Authorized Field Change

AFC G-01913

Subject: Fender Extension Modification for 4300 and 4400 Models with 8000 Lb. Steer Axle, Code 02ADV, Built Between October 24, 2000 and October 17, 2001 to Eliminate Tire Contact when Maneuvering Tight Turns

Figure 1 Removing Fender Extension- Drivers Side Shown

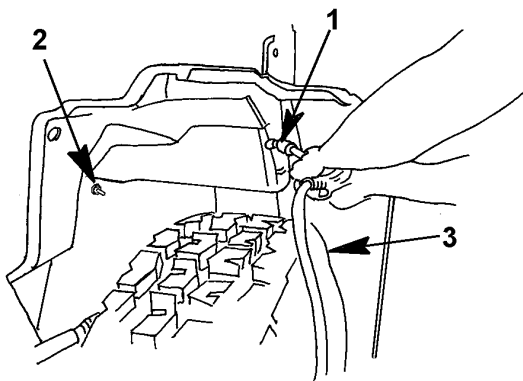
1. Unlatch and tilt the hood to the open position.
2. Remove the mounting bolts and nut from the fender extension (Figure 1).
3. Remove the fender extension.

1. MOUNTING BOLTS (1)
 2. NUT ON MOUNTING STUD
 3. MOUNTING BOLT (NOT SHOWN IN VIEW)
4. Repeat Steps 2 and 3 for the other side.
 5. Remove two bolts from the cab mount bracket at the sled runner (Figure 3) and install the fender extension flap from Kit Number 8000827R91. Make sure the rubber flap is positioned to the outside, the metal bracket (Figure 2) against the cab mount bracket sled runner. Re-install the bolts and tighten to 88 to 106 Lbf-ft (119 to 144 Nm).

11. Use a shop reciprocating saw or router to cut the fender extension following the pattern laid out in Step 10.
 12. Re-install the modified fender extensions. Install a washer from Kit 8000827R91 on the mounting stud, Item 2 in Figure 1, between the fender extension and the nut. Tighten the fasteners to 34 to 38 Lbf-ft (46 to 52 Nm).

Figure 5 Fender Extension Layout- Drivers Side

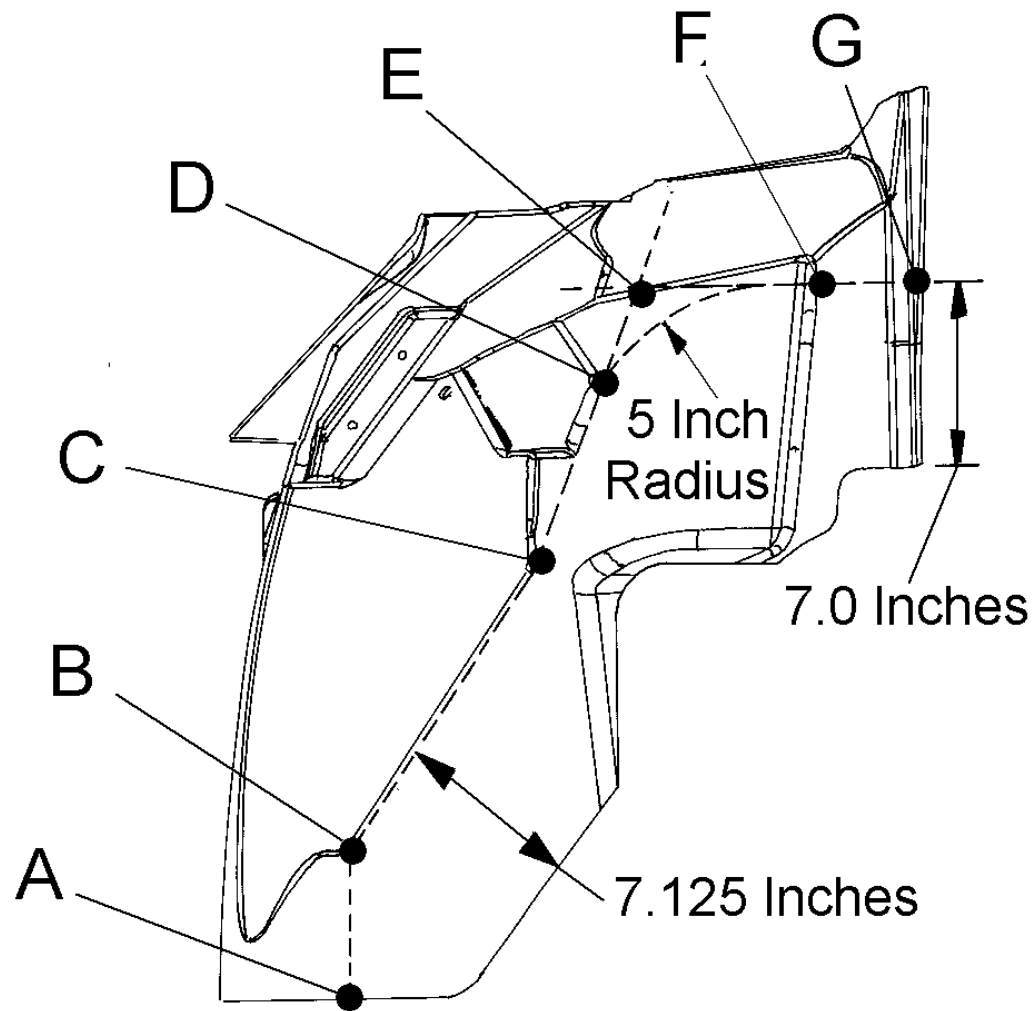
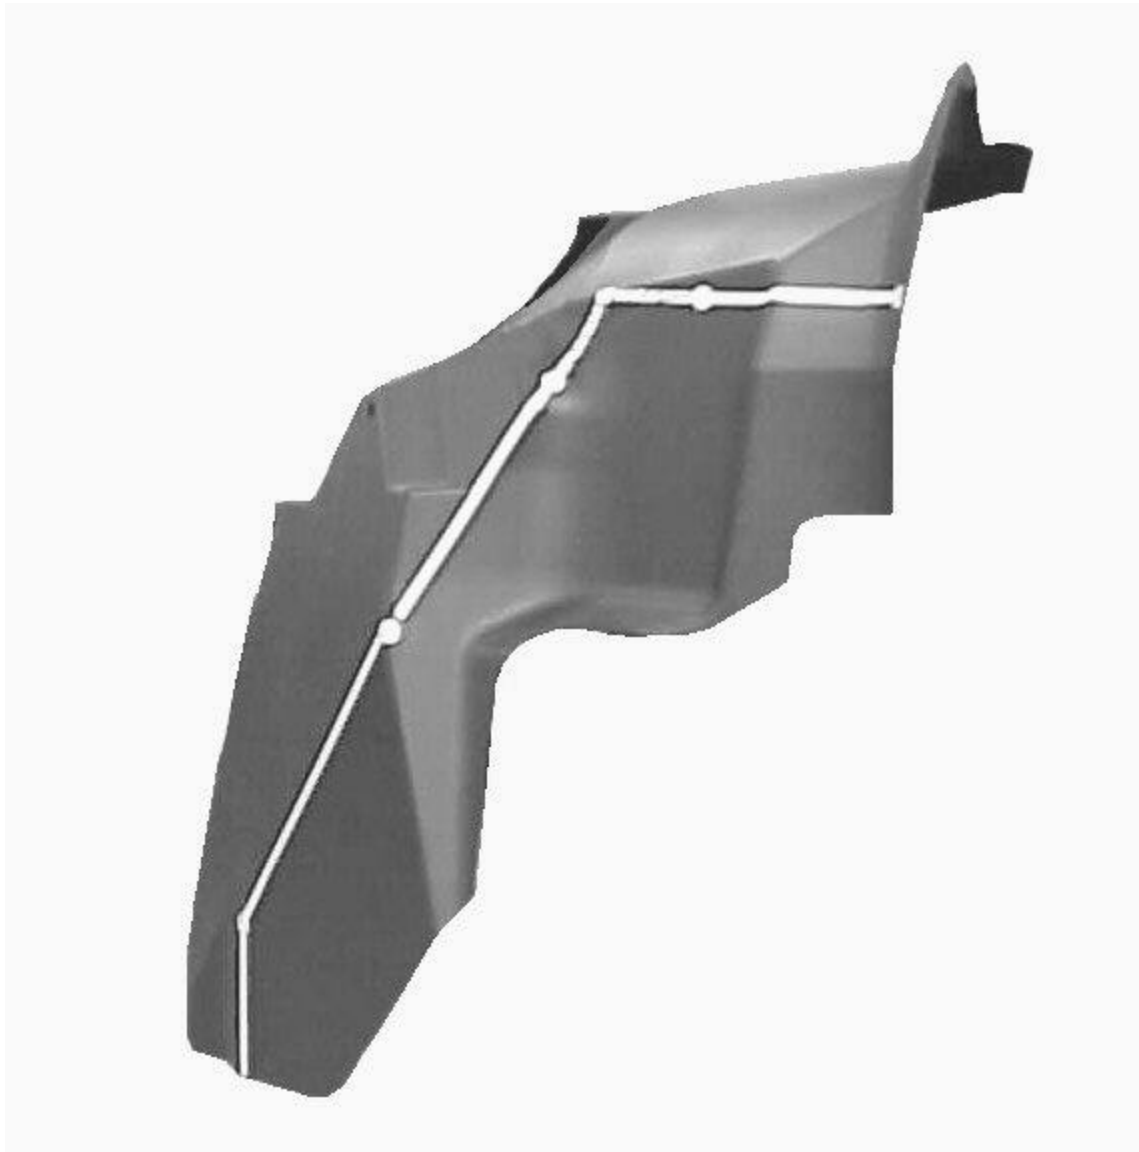
8. Repeat Step 7 for the other side.
 9. Prepare the removed fender extensions for modification by cleaning the surfaces of all road debris.
 10. Use Figure 5 (driver side) and Figure 7 (passenger side) to layout or mark the area to be removed on the convex side (surface on the frame rail side or car line side) of the fender extensions.

- NOTE – The lines being marked will generally follow the contour break lines of the fender extension surface. Do not cut into the contour break lines to retain fender extension stiffness.**

- Set up the fender extension in car line position as shown in Figure 5 and Figure 6.
 - Locate and mark points B and C along the contour break line at 7.125 inches from the edge (Figure 5).
 - Locate and mark a vertical line from the bottom edge at point A through point B (Figure 5).
 - Locate and mark horizontal line E-G 7.0 inches from the edge as shown in Figure 5.
 - Locate and mark line C-E following the contour break lines as shown in Figure 5.
 - Locate and mark a 5 inch radius between line C-E and E-G (Figure 5). Points D and F are the tangent points or blend points of the 5 inch radius.

Figure 7 Fender Extension Layout- Passenger Side

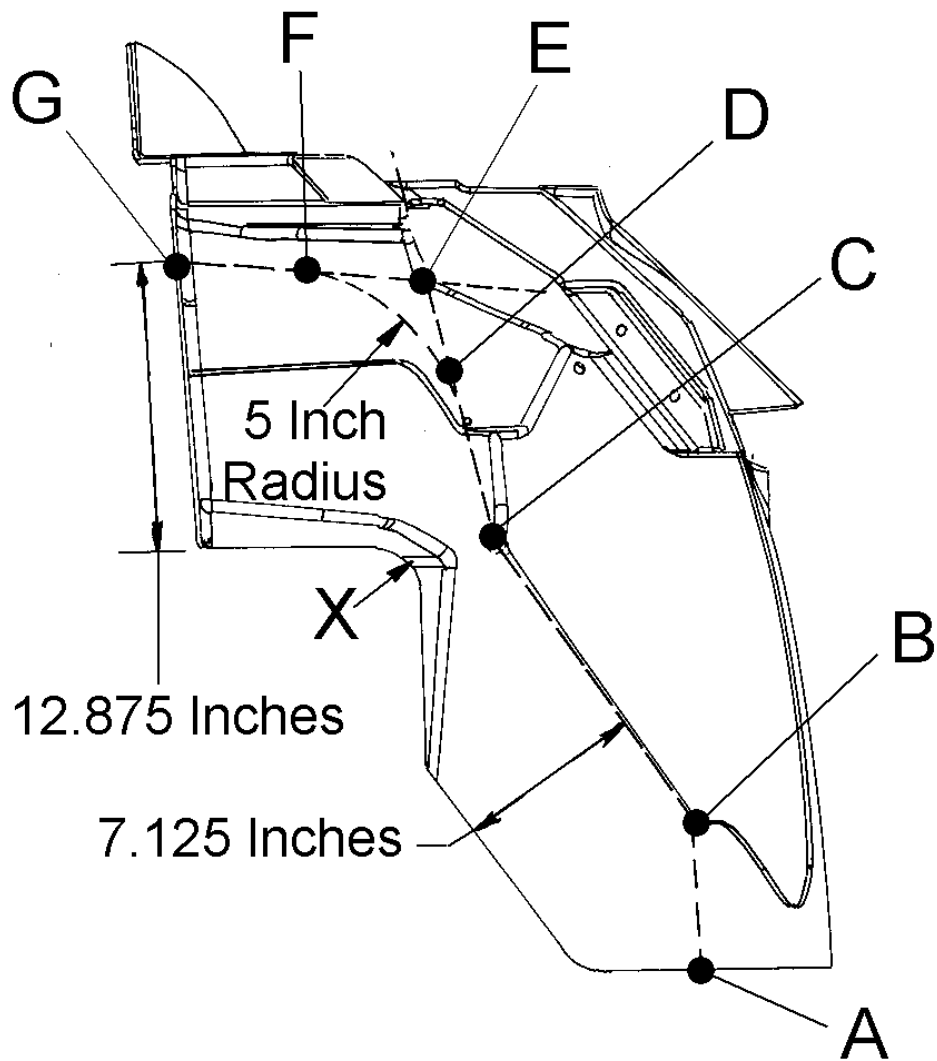
- Set up the fender extension in car line position as shown in Figure 7 and Figure 8.
- Locate and mark line B-C along the contour break line at 7.125 inches from the edge as shown in Figure 7.
- Locate and mark a vertical line from the edge at point A to point B following along the contour break line (Figure 7).
- Locate and mark line C-E along the contour break line (Figure 7).
- Locate and mark point G, 12.875 inches from the edge as shown in Figure 7.
- Relocate point E, along line C-E, so that it is approximately 11 inches from the inside radius noted with a X in Figure 7.
- Mark a straight line between points E and G (Figure 7).

- Locate and mark a 5 inch radius between line C-E and E-G (Figure 7). Points D and F are the tangent points or blend points of the 5 inch radius.
